South Gloucestershire Council

Our Reference: P22/01300/O

RE: LAND AT SODBURY ROAD, WICKWAR GL12 8PG

- 1.1 This is an outline application for the erection of up to 180 dwellings, a local shop and associated infrastructure (Outline) with access to be determined; all other matters reserved.

- Extract of Plan EDP3 showing assessment viewpoints:

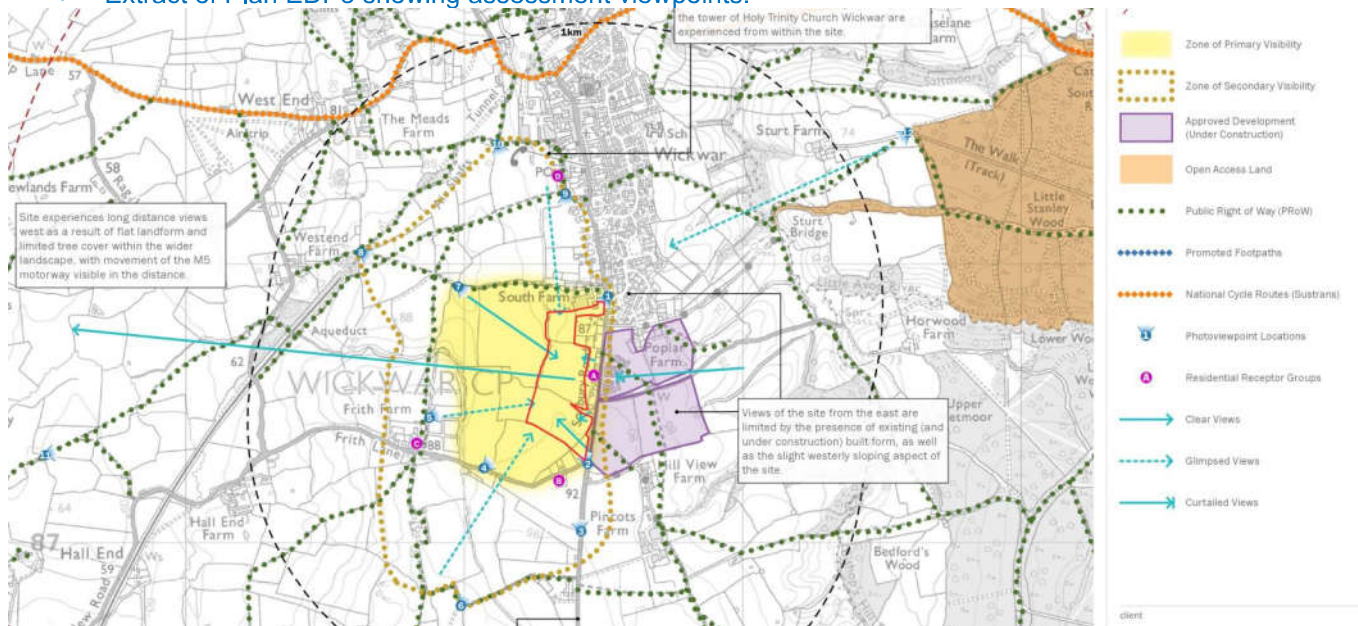
- EDP 3: Findings of EDP's Visual Appraisal - representative assessment viewpoints have not been agreed with SGC, as requested in Screening Opinion feedback. Potential visual effects also need to be assessed from the following viewpoints:

- There is a sequence of views between South Farm and VP7 on the footpath/linear receptor lying parallel to the northern site boundary, including viewpoints with more open/worse case views of the proposals than depicted by VP7 and at least one additional, intermediate viewpoint needs to be assessed.

- There are also views between VPs 7 and 8 on same route, and a further intermediate/worse case view needs to be also assessed from here.
 - Footpath LWR/25 within the CA, further west of VP 9, to complete the visual analysis provided by VPs 9 and 10. On the footpath extending between VPs 8 and 9, which follows the southern boundary of the CA, there are views back to the Grade II* listed church in the CA and also clear views across the site to the buildings being constructed on the opposite side of Sodbury Road. There are clear view lines/vistas towards No. 1 Frith Lane/VP 4, the views from which is discussed below. There is no clear view of the site from the Royal Observer Corp Volunteers pill box.

- Frith Lane between VPs 2 and 4, where a field gate affords a clear view towards the site and surrounding part of Wickwar. From VP 4 the proposed POS margin will appear foreshortened in the view. The tower of the Grade II* listed church of The Holy Trinity, within the conservation area, is clearly seen on the skyline to the left (north) of the listed South Farm. Current, proposed layout would not preserve this view line/vista. There is also a clear view of the church tower from opposite No. 1 on Frith Lane, and there may be other noticeable views of the church in the vicinity of VPs 2 and 3 in winter when adjacent skyline trees have lost their leaves.

- There are open/panoramic views from the section of Sodbury Road across the southern part of the site (in the vicinity of VP2) of the wider landscape setting of Wickwar and countryside surrounding it; these will be wholly lost in terms of the current development proposals.

- B4060 between VPs 2 and 3, where there is a more open view than that from VP 3; the proposed housing within the SE corner of the site/frontage will be visible and will effectively 'combine' with the new housing on the opposite, east side of Sodbury Road to create an 'enclosed, built corridor' approach into the village.

- Consider that there will be some key views of the proposals from the footpath route crossing higher land near VP 5/paddocks, in which the new housing will be quite noticeable/prominent rather just glimpsed as annotated on the plan; this needs further review in the LVA.

- The proposals will be seen in views from the listed Frith Farmhouse.
 - VP11 does not appear to be annotated on Plan 3.
 - Consider that the Zone of primary visibility needs to be extended to take account of the above site observations (e.g. pass VP 7 and also to take in VP5).
